**Revised<sup>1</sup> Pre-Hearing Statement of Advisory Neighborhood  
Commission 6C**

**District of Columbia Board of Zoning Adjustment  
Appeal No. 19550**

This appeal relates to 1125 7th St. NE, also known as square 886, lot 35 (“the Property”) in the RF-1 zone. The Property’s owner of record is Atlas Squared, LLC, 7926 Jones Branch Drive, Ste. 600, McLean, VA 22102-3373. The Property lies entirely within the boundaries of ANC 6C.

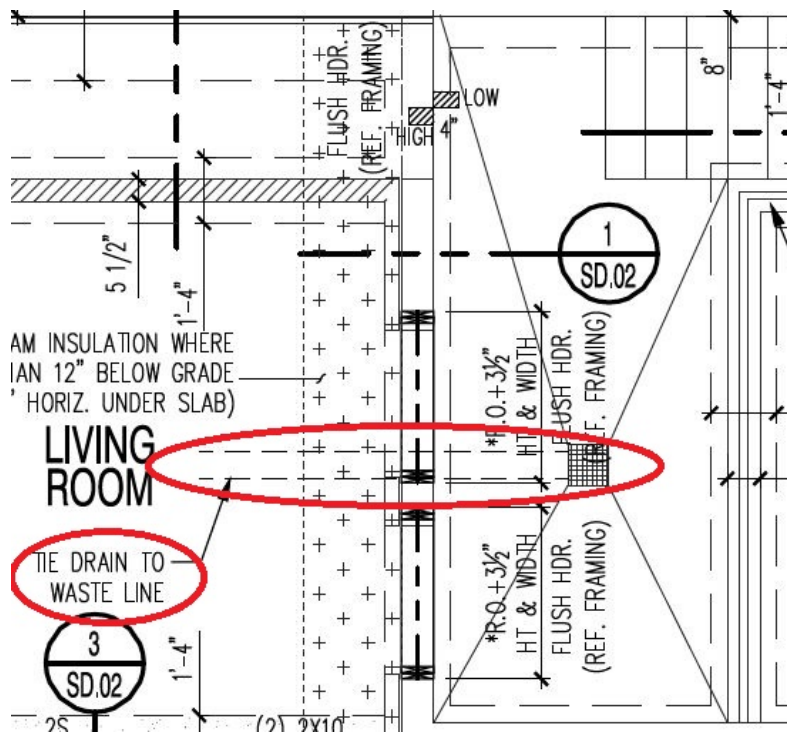
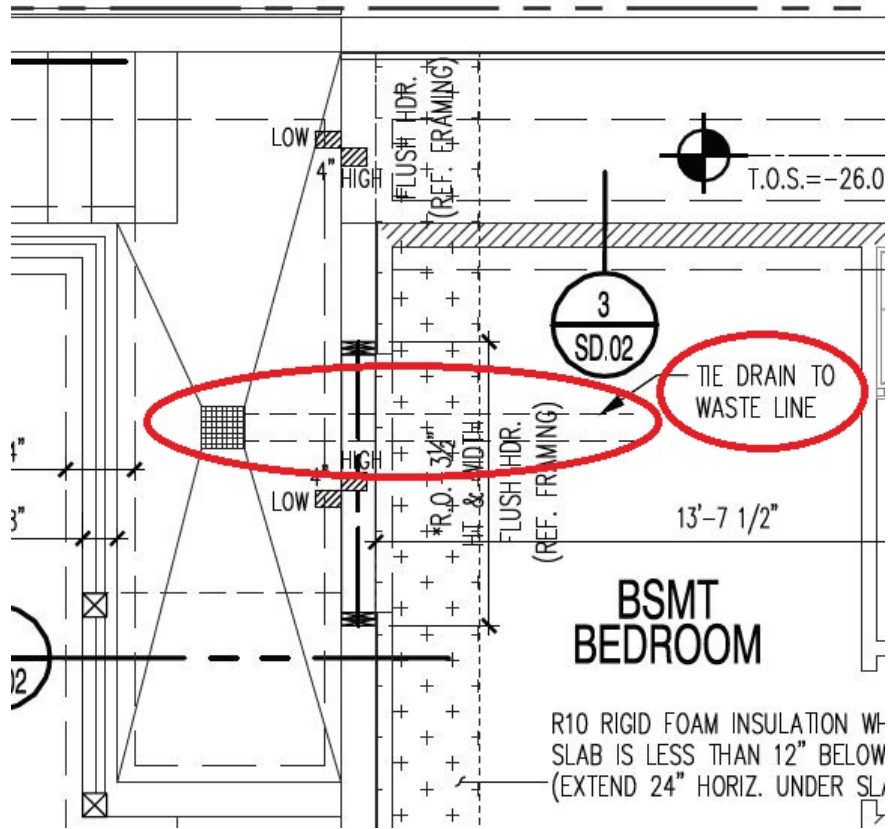
In fact, this 40% figure is patently false. Most obviously, each and every one of the “wells” shown on the plat consists not of soil allowing water percolation, but instead of impervious concrete sloped toward a drain tied into the waste line. Permit drawing S.01 (*see* Tab C) depicts this unambiguously in multiple places:

These areaways, which have a combined area of over 300 square feet, in no way satisfy the definition of “pervious surface” in the regulations. As a result, the applicant’s claim that 40% of the lot is “permeable area” is incontrovertibly false. The pervious-surface figures on the plat must therefore be disregarded in their entirety, and the individual plan drawings examined for explicit indications that pervious surface is planned.

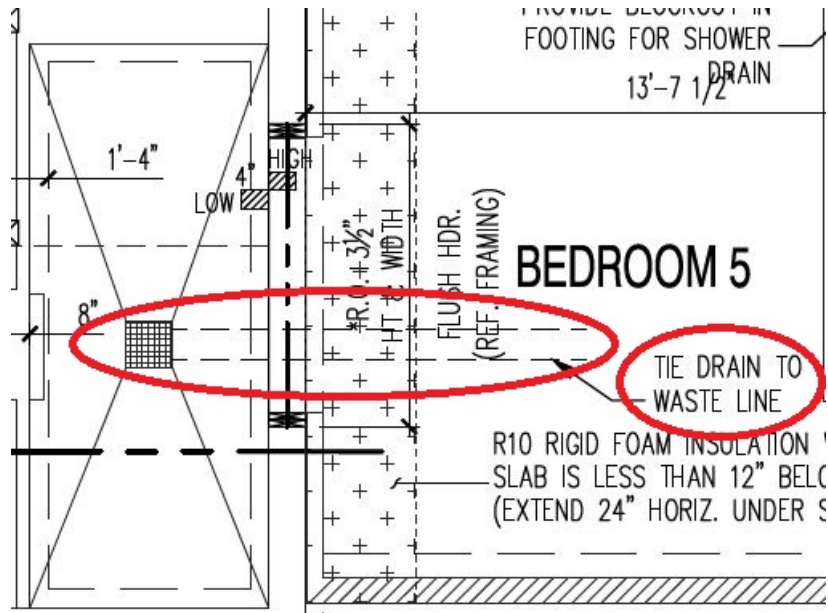
As shown on the Permit application plat (copy at Tab D), the Property has a lot area of 2331.6 square feet. Construction on the site therefore requires a minimum pervious surface area of 20% of that area, approximately 466 square feet.

The plat claims that the “un-hatch” area—that is, the entire 40% of the lot not covered by structures—is “permeable area.” This comprises the center courtyard; several “wells” (areaways), stoops, and exterior stairwells; and the parking spaces abutting the alley.

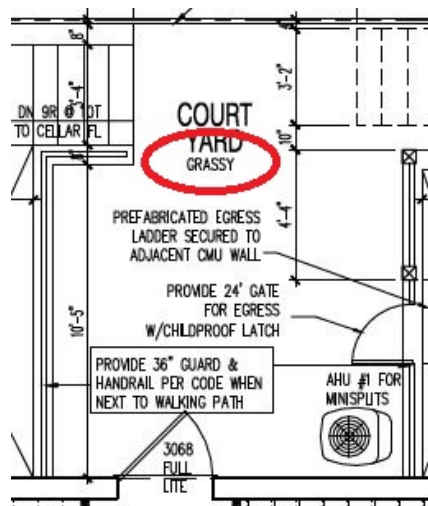
Indeed, the lone pervious-surface marking we have located in the plan drawings is for the central courtyard (sheet A1.1), which labels it “grassy”:

Although the plans do not provide specific dimensions for this portion of the Property, our measurements indicate that this area covers only 156 square feet, or less than 6.7% of the overall lot area. (This calculation generously ignores the air-conditioning unit seen above.) Even if our calculations were off by 100%—and we respectfully submit that they are not—the labeled “grassy” area would still fall far below the minimum 466 square feet of pervious surface required by the zoning regulations.<sup>3</sup>

Sheet A1.1: Cellar-unit water heaters in rear structure (left) and front structure (right)

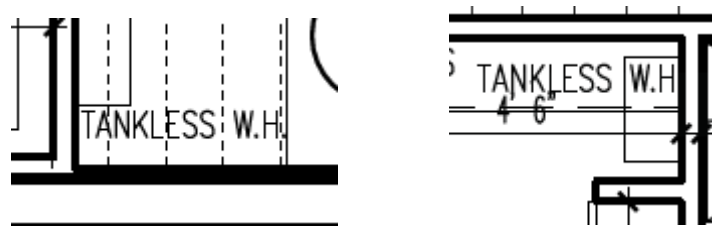
Sheet A1.1 of the Permit drawings (*see* Tab C) shows a functioning separate unit on the cellar level of each of the two (front and rear) structures. Each cellar unit has a bedroom. Each cellar unit has full bathroom. Each cellar unit has a “living room” featuring a refrigerator, dishwasher, and large kitchen-style sink. And each cellar unit has its own tankless water heater separate from the water heaters in the two units (front and rear) on the first floor:

Sheet A1.1: Cellar-unit laundry facilities in rear structure (left) and front structure (right)

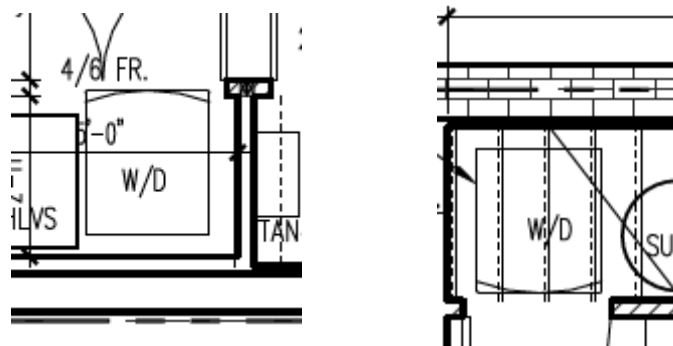
Moreover, each cellar unit has its own laundry facilities (marked “W/D”) distinct from the laundry facilities in the front and rear upper units. These four separate washer/dryer units appear clearly on Sheet A1.1 (cellar level) and Sheet A2.1<sup>4</sup> (second floor):
